## **Revised pivot bolt for 9t INTRA axles**

Tel. +49 6095 301-0 · info@safholland.de · 2023-10-10 · XL-AZ10117WI-en-DE

# Important Information 117 – Technology

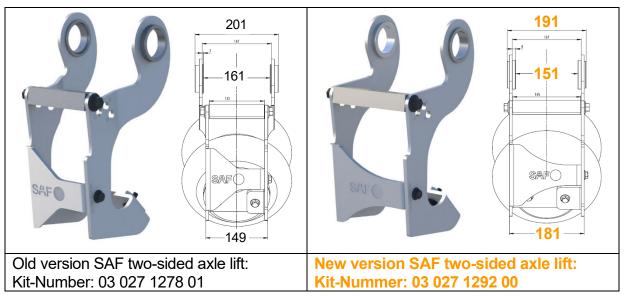
Due to the changed geometry of the screw connection, problems may arise during the installation of <u>self-developed</u> two-sided axle lifts. We urgently ask you to contact the design engineer at SAF-HOLLAND responsible for your company in order to clarify details and thus to avoid possible problems with self-developed two-sided axle lifts in advance.

At the same time as the optimized pivot bolt screw connection, a modified SAF two-side axle lift will be introduced:
